## SUBMITTAL TRANSMITTAL

October 20, 2011  
**WGCM Submittal No. 03200 - 004.C**

**PROJECT:** **HAROLD D. THOMPSON W.R.F.**  
 9001 Birdsell Road.  
 Fountain, Colorado 80817

**SUBJECT** Dalco Drain Pipe Encasement Plan - Drawing P12A  
 Slab @ Headworks - Sec's. & Elev. @ headworks.  
 • Drawings: P5. P6. P7, P8, P9, P10, P11, & P12.

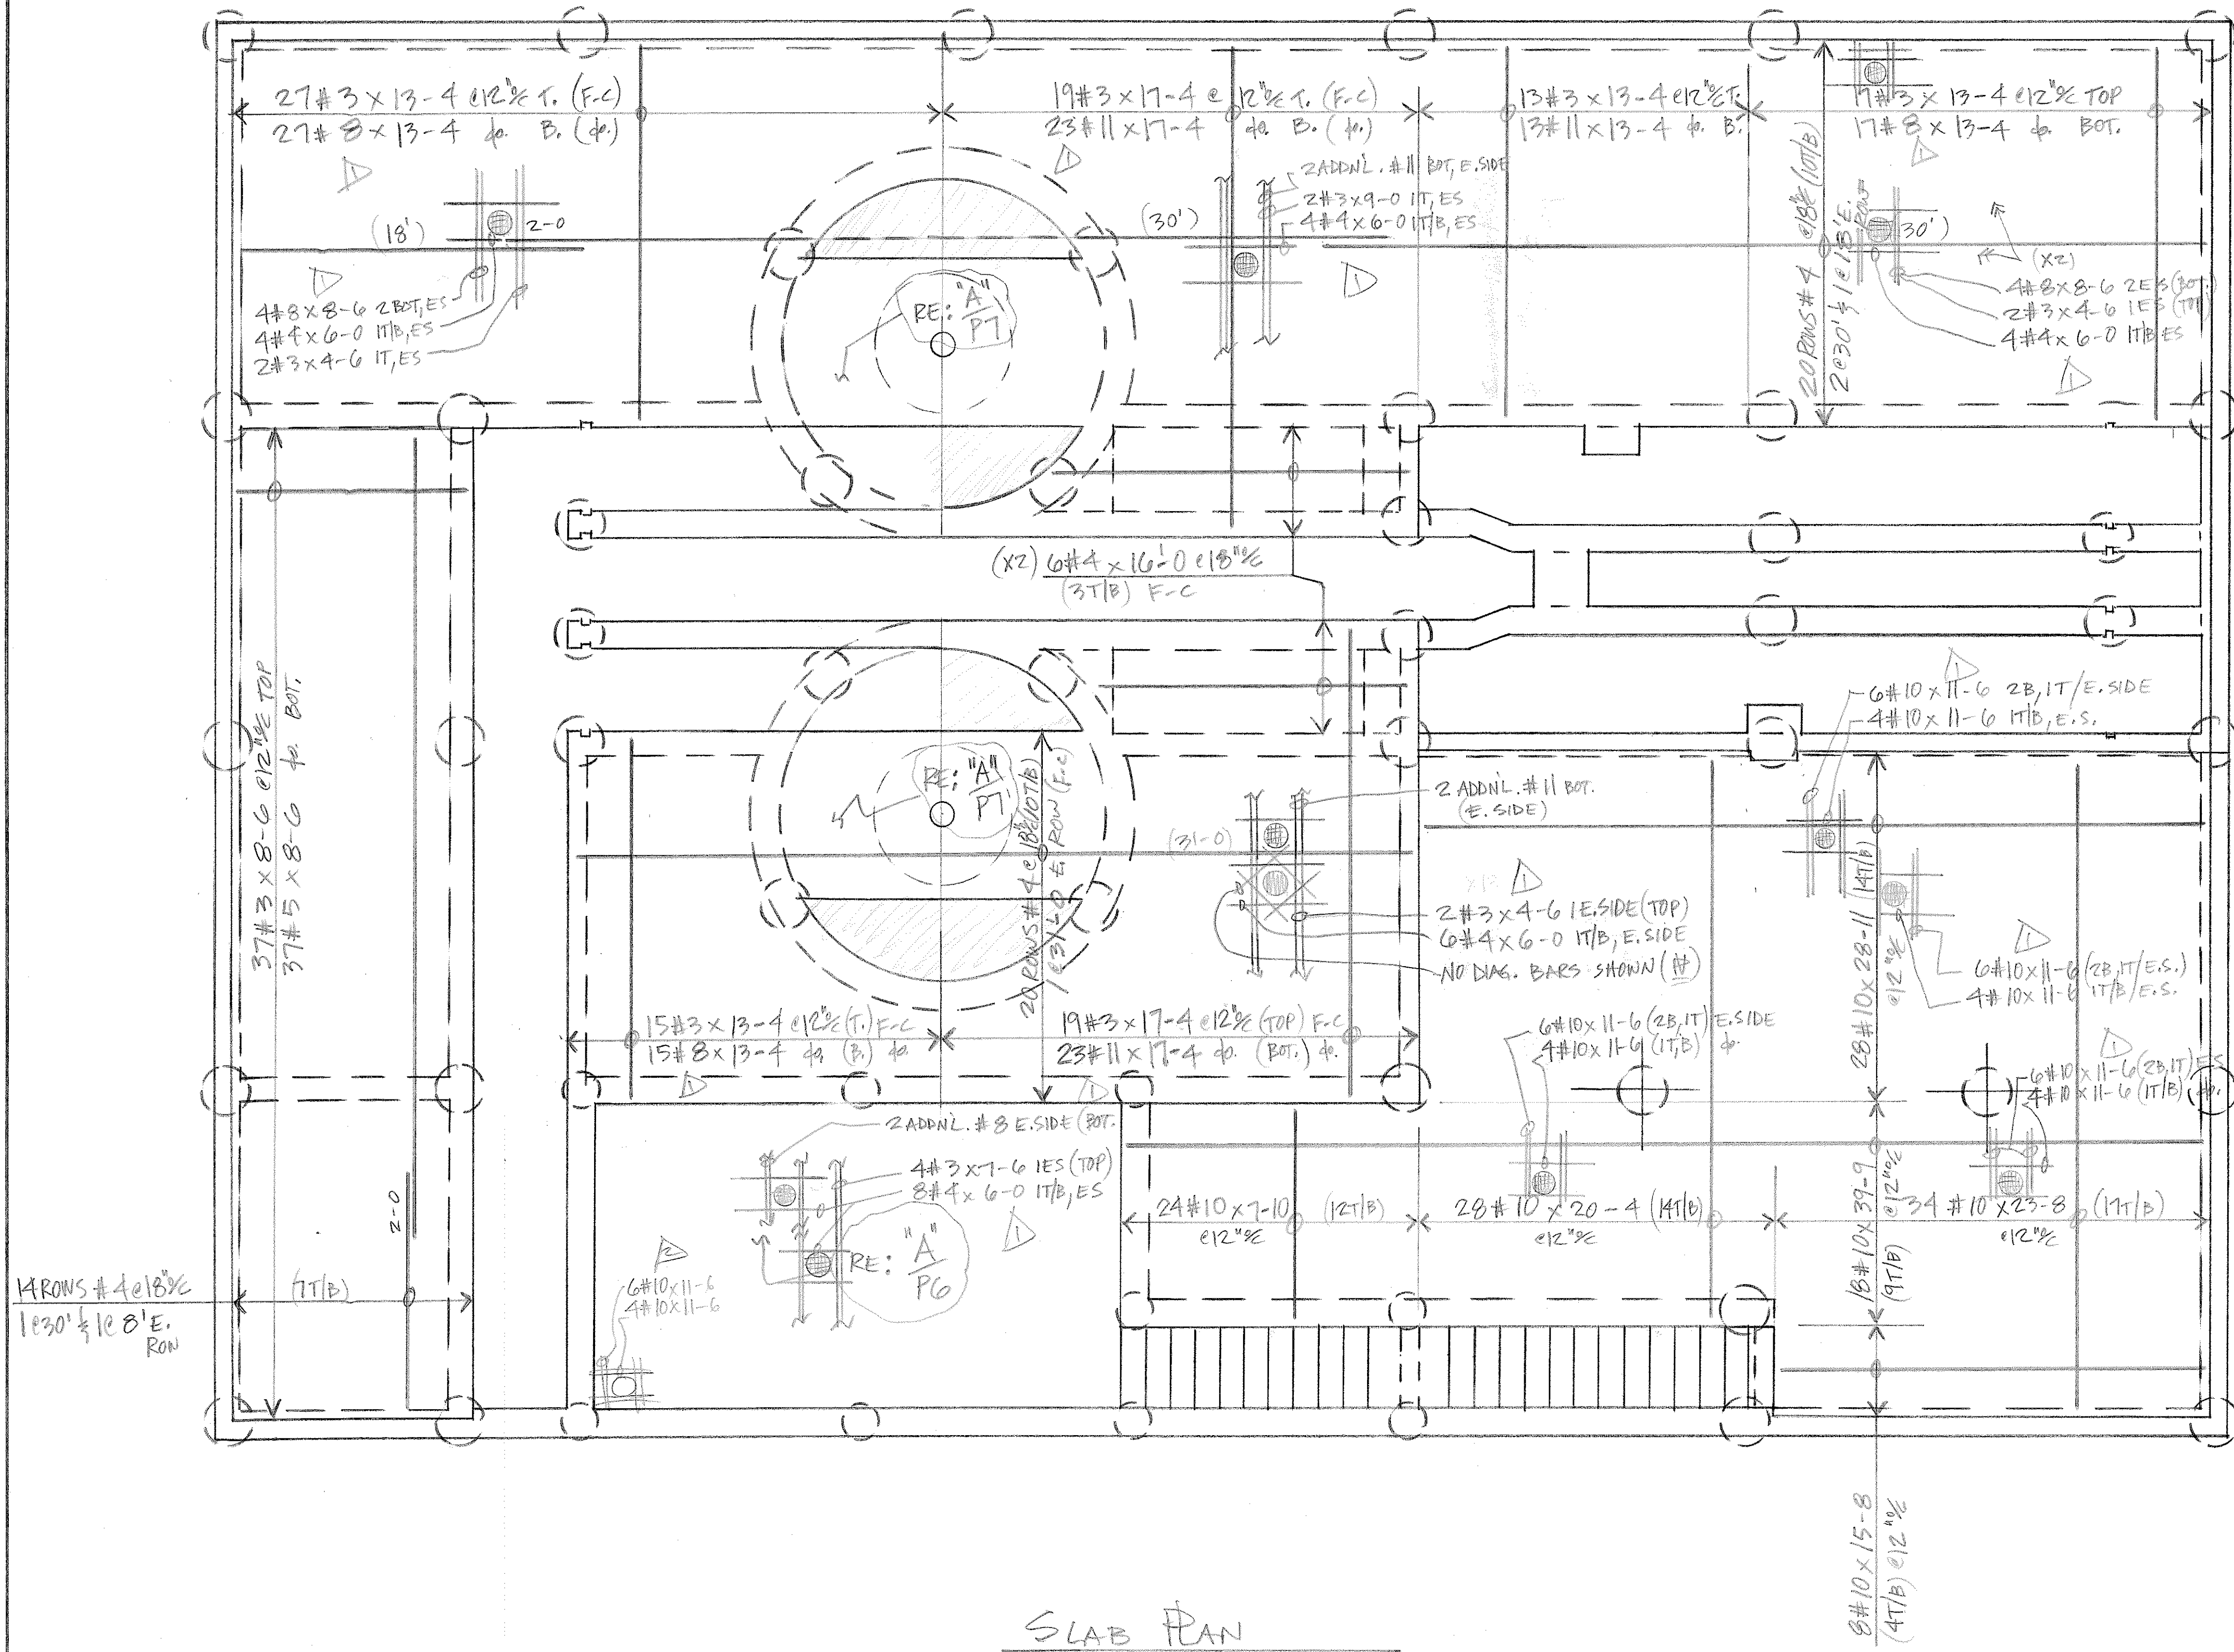
1. Dalco Drawing P12 Revision 3 Note
  - Remove: "Provide full length #5, #8, & #11 Bottom Slab Bars – Do not Splice"
2. Ref: e-mail September 26, 2011 – John Jacob – (attached).
  - *The #4 bottom bars, there was no markup comment on these bars, and therefore these can be spliced.*
  - *The no splice requirement is only for the #5, #8 and #11 bottom reinforcing bars which act as the primary reinforcing in the span (short) direction for the one-way slab design.,*
3. End of Review

PROVIDE FULL LENGTH  
#5, #8, 1/2 #11'S BOT.  
SLAB BARS - DO NOT SPICE
